City of Portland, Maine - Building or Use Permit Application
 389 Congress Street, 04101 Tel: (207) 874-8703, Fax: (207) 874-8716

Permit No: 03-0219	Issue Date: MAY 22 2003	CBL: 083B A002001
-----------------------	-----------------------------------	----------------------

Past Use: Vacant Lot	Proposed Use: Single Family	Permit Fee: \$4,598.00	Cost of Work: \$600,000.00	CEO District: 1	<i>IR-J</i>
Proposed Project Description: Construct "New" Single Family Home, 4,300 SF		FIRE DEPT: <input type="checkbox"/> Approved <input type="checkbox"/> Denied	INSPECTION: Use Group: <i>R3</i> Type: <i>5B</i> <i>BOCA 1999</i>

RE: Neal Residence
 30 West Shore Drive
 Great Diamond Island
 Responses to May15,2003
 Building Permit Review items

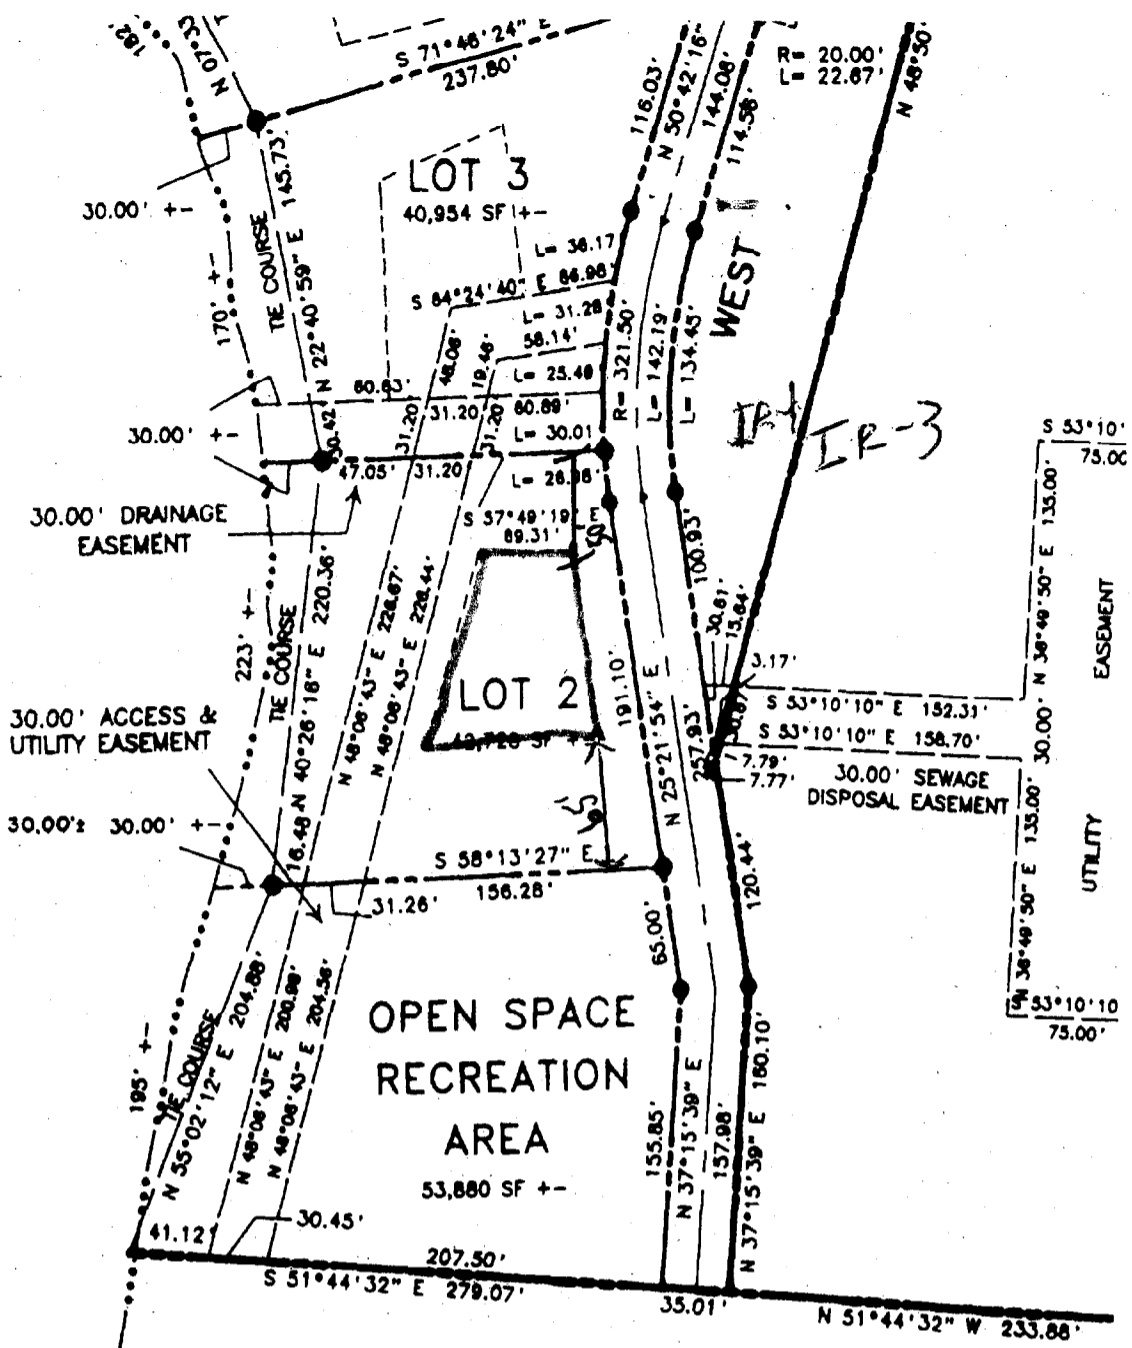
5/8/03 - envelope changed. Approved by Lee H. - New my LAR being recorded
